**AGENDA**  
**HISTORIC PRESERVATION ADVISORY BOARD MEETING**  
**City Hall, 385 South Goliad, Rockwall, Texas**  
**Council Chambers**  
**December 19, 2019**  
**6:00 P.M.**

## HISTORIC PRESERVATION ADVISORY BOARD CASE MEMO

**TO:** Historic Preservation Advisory Board  
**DATE:** December 19, 2019  
**APPLICANT:** Ryan Miller, *Director of Planning and Zoning*  
**CASE NUMBER:** H2019-019; *COA for 810 N. Goliad Street*

**SITE PLAN**

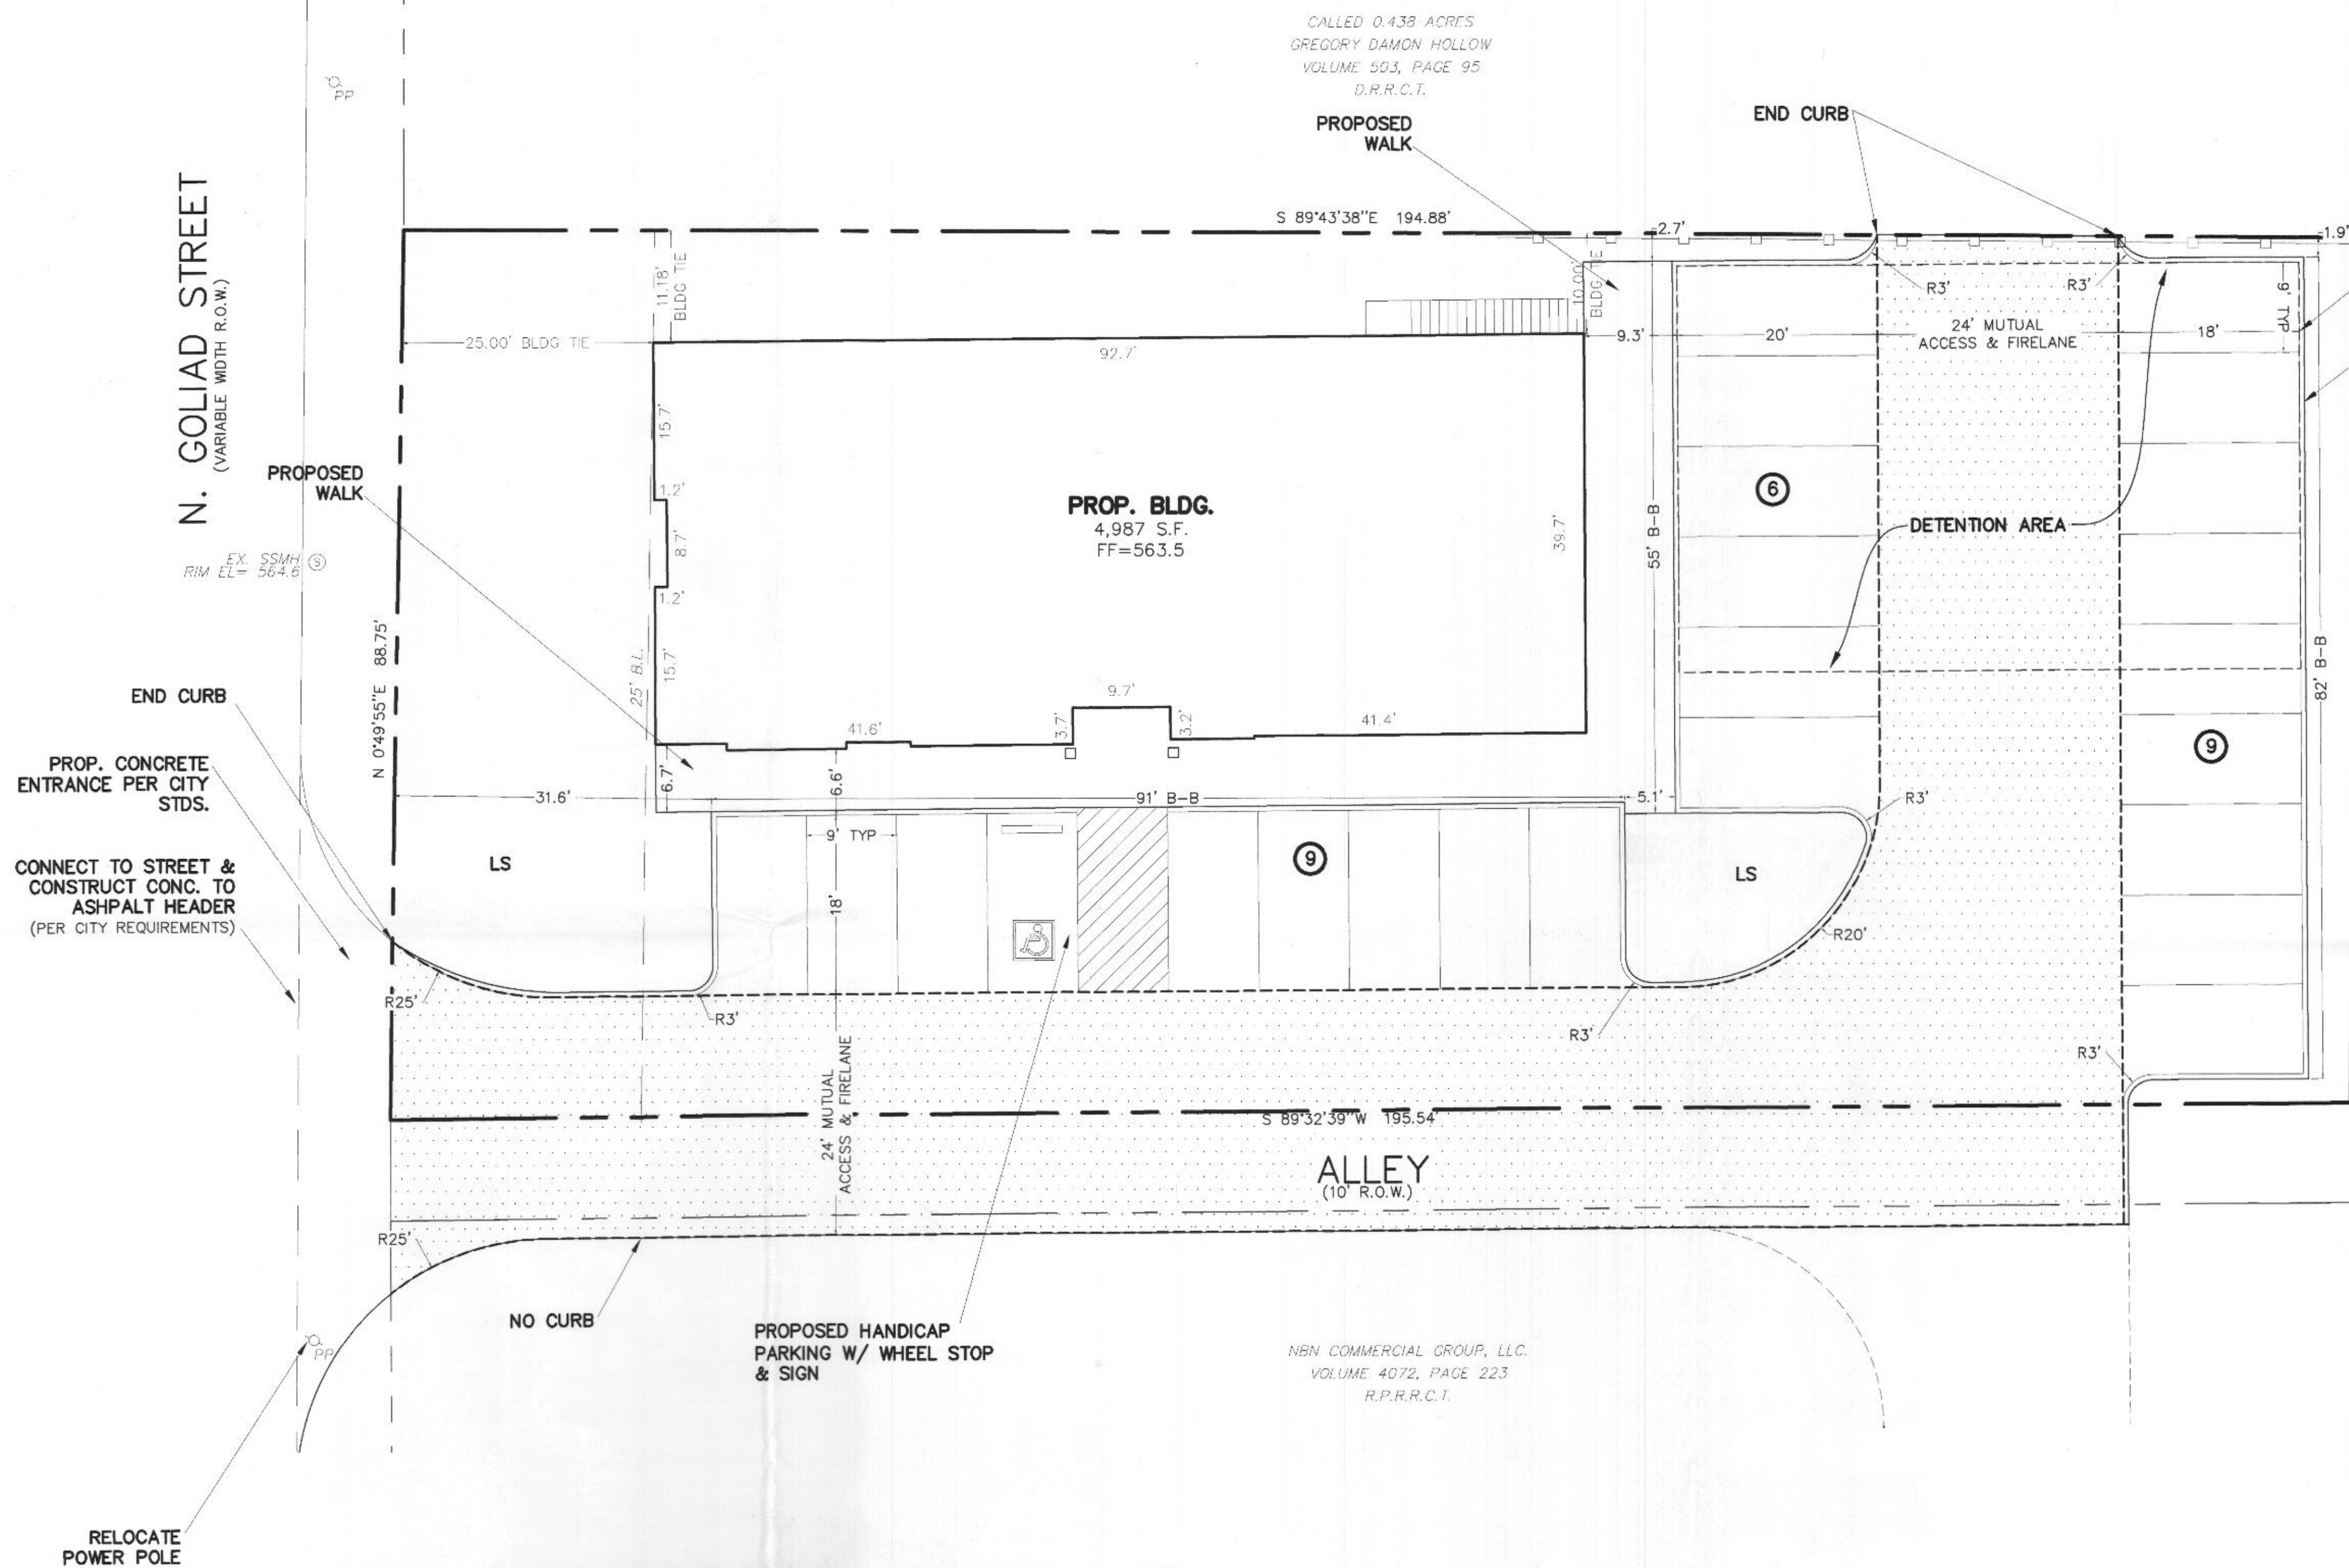
- (5) **Front Yards.** As was stated previously, staff has recommended to the applicant changing the western building elevation to incorporate an entryway giving the appearance that the property fronts to S. Goliad Street. In addition, the applicant will be required to provide a detailed landscape plan with the site plan for the front yard areas.

- (6) **Side Yards.** The proposed site plan does appear to conform with the majority of the guidelines’ suggestions relating to the side yard; however, staff should point out that currently a staircase appears to be in the ten (10) foot side yard setback. This encroachment would require approval by the Board of Adjustments (BOA) prior to the approval of the site plan.

- (10) **Parking Areas for Commercial Development.** According to the guidelines, “(a)ll parking lots for more than five (5) vehicles and having frontage on a public street should be screened from the street by an evergreen hedge not lower than three (3) feet nor higher than four (4) feet tall. If a hedge is not desired than an earthen berm, masonry wall, or combination thereof may be substituted ...” The applicant is currently not showing the incorporation of any screening for the parking areas. Staff has added this as a condition of approval of the Certificate of Appropriateness (COA).

With respect to the remainder of the proposed site plan staff has identified the following issues relating to the requirements of the Unified Development Code (UDC) that will need to be addressed with the site plan prior to approval from the Planning and Zoning Commission:

(SF-7) District. Currently, there is an existing six (6) foot chain-link fence on this property that is adjacent to the eastern boundary of the subject property. Section 8.02, *Non-Residential Fences*, of Article VIII, *Landscape and Screening Standards*, of the UDC goes on to allow wood fences in conformance with the residential fencing standards for new residential fences be permitted in the Residential-Office (RO) District. Based on the applicant's submittal, staff is of the opinion that it would be appropriate for the applicant to either [1] request to incorporate three (3) tiered screening adjacent to the existing chain-link fence or [2] establish a new wood fence with canopy trees on 20-foot centers; however, this is a discretionary decision for the Planning and Zoning Commission at the time of site plan.

- (2) *Landscape Plan*. A more detailed landscape and treescape plan will be required to be submitted to ensure compliance to the tree planting requirements, which require a minimum of one (1) canopy tree and one (1) accent tree be planted adjacent to N. Goliad Street per 100 linear feet of frontage.

- (1) A more detailed Landscape and Treescape Plan shall be submitted with the site plan showing conformance with the following:
  - (a) Landscaping and/or a berm -- *generally in conformance with the Historic Guidelines* -- should be incorporated in between N. Goliad Street and the parking lot to screen the parking areas;

- (2) The alleyway situated on 808 N. Goliad Street will need to be verified prior to the approval of a site plan. Alternatively, the applicant can secure a cross access easement on the property;

- (5) The proposed building elevations are subject to review by the Architectural Review Board (ARB) as part of the site plan approval process;
- (6) A cross access easement (as depicted on the site plan) will need to be establish at the back of the subject property extending from the southern boundary of the subject property (*adjacent to 808 N. Goliad Street*) and extend to the northern boundary (*adjacent to 812 N. Goliad Street*); and,
